**RESOLUTION NO. 2019-52**

**A RESOLUTION OF THE VILLAGE BOARD OF THE VILLAGE OF CALEDONIA TO APPROVE A CONDITIONAL USE TO CONSTRUCT AND UTILIZE A ±4,970 SQUARE-FOOT COMMERCIAL BUILDING FOR RENT OR LEASE LOCATED AT 3873 27TH STREET IN THE VILLAGE OF RAYMOND UNDER THE COOPERATIVE PLAN DATED NOVEMBER 12, 2009 BETWEEN THE VILLAGE OF CALEDONIA AND THE VILLAGE OF RAYMOND UNDER SEC. 66.0307, WIS. STATS.**

**TO:** Village of Caledonia Planning Commission  
**CC:** Tom Christensen, Elaine Ekes, Jarmen Czuta  
**FROM:** Jeff Muenkel AICP  
**RPT DATE:** April 18, 2019  
**MTG DATE:** April 29, 2019  
**RE:** "Javco Realty" – Town of Raymond Coop Boundary Request

# Javco Realty Project Report

PROJECT NAME: JAVCO REALTY  
PROJECT SITE ADDRESS: 3873 S 27TH ST  
FRANKSVILLE, WI - RACINE COUNTY  
BUILDING SIZE: 50' X 70' X 17'-8" AND 42' X 35' X 12'-8"  
SHEET NAME: ELEVATIONS

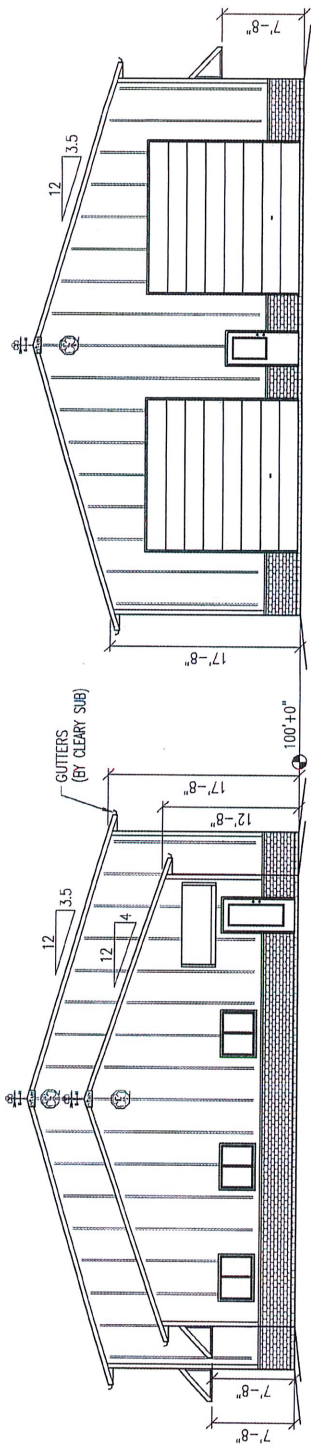
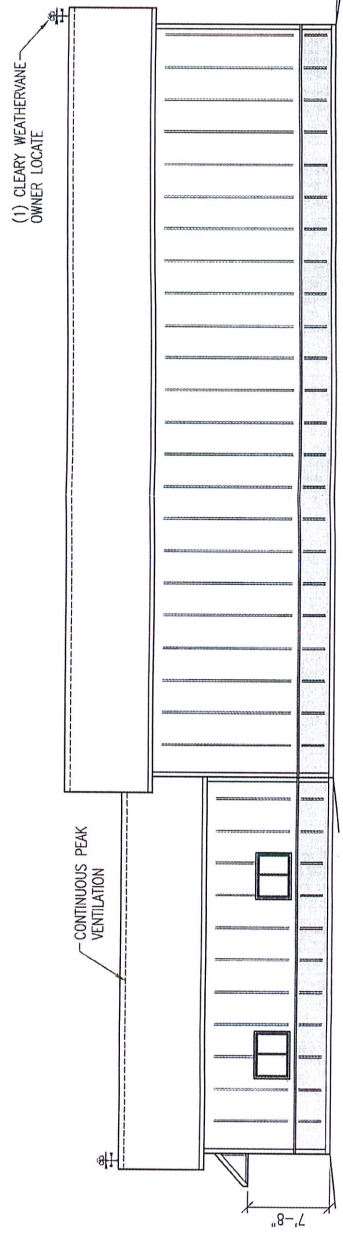
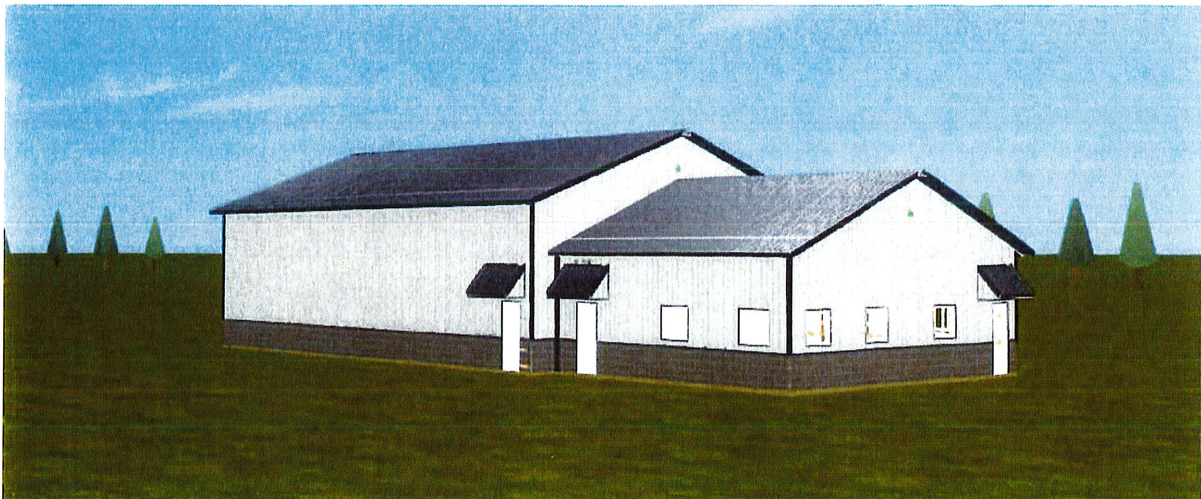
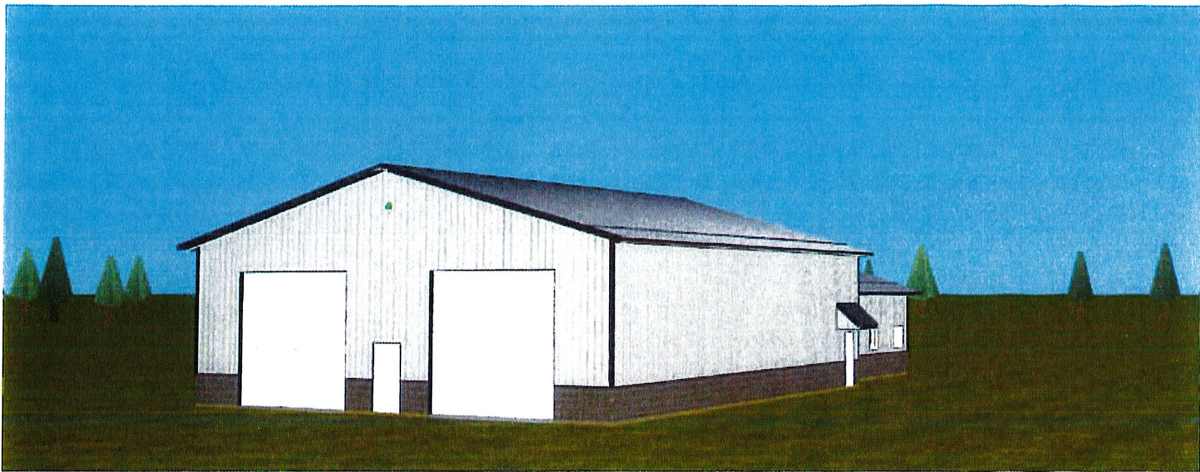
3. Four Sided Architecture Required – Requires similar architecture and use of materials throughout all facades of a proposed structure.
  - a. The proposed utilizes four-sided architecture subject to any Plan Commission discussion on types of materials being used per sub section 7 below.

- a. A standing seam metal roof is proposed. These types of buildings are commonly found along the 27<sup>th</sup> St frontage road here and have been approved in the existing industrial park by Caledonia in the previous years. If other agreement recommendations herein are followed the proposed architecture should be fine and appropriate.

- a. A metal façade with a 4-foot band of brick is found (brick on south, east, and west elevations). As previously noted, metal buildings are common along this industrial park frontage road here. Plan Commission has approved the metal buildings as long as the rest of the boundary agreement items have been met, the front facades have ample brick product, and ample screening is found. Plan Commission may wish for the petitioner to add more percentage of brick to the front façade.

BUILDING PLANTING PLAN  
SCALE: 1/8" = 10'-0"

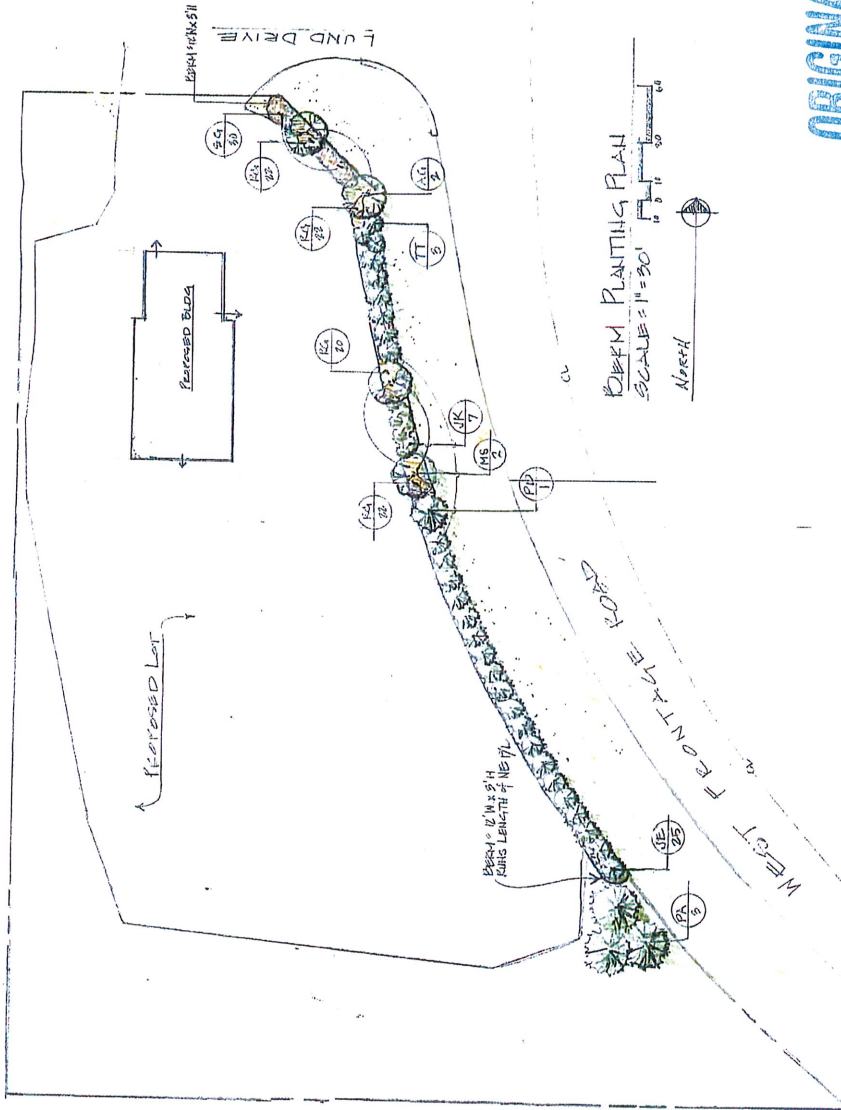
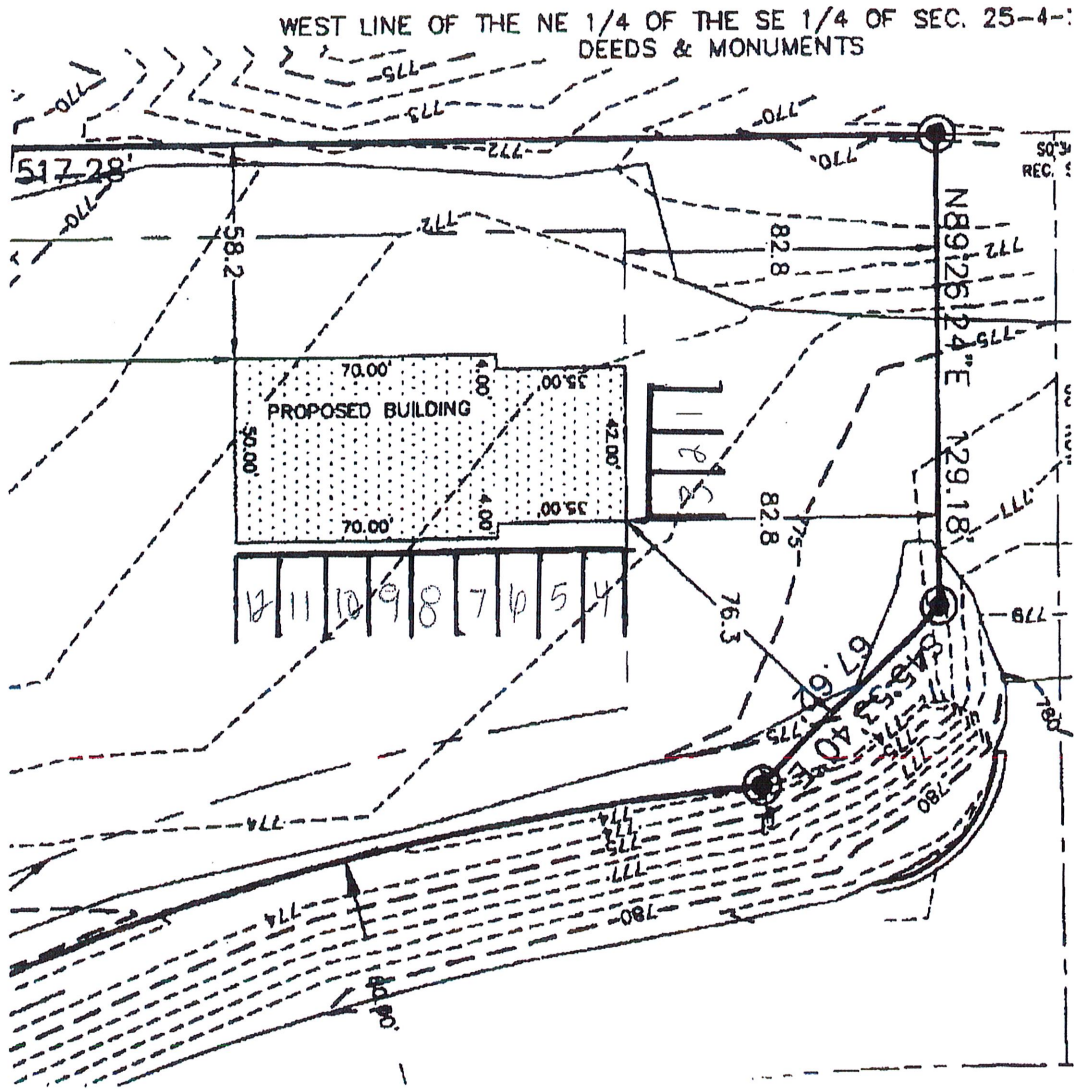
- a. Overhead doors are only found on the west façade which faces away from the roadway and public view. The use of the large gravel areas around the entire structure are undefined at the moment. Dense landscaping is proposed along the frontage of the property, which will screen this gravel area if outdoor storage is the use in the future. However, this possible outdoor storage and parking area will be viewable from the south. Dense landscaping along the southern lot line is recommended.

2. Street Edge Landscaping Required – Requires street frontage landscaping with trees 50’ on center minimum and/or berms for screening.
  - a. Dense landscaping proposed at a rate more than the minimum. Coniferous trees mainly proposed in plantings heights of 5’. Will be dense within a few years.

2. The landscape plan shall be updated to have similar dense landscaping along the southern property line to screen the future uses of the southern gravel outdoor storage/parking lot area. This can be approved at the time of submitted building permits.
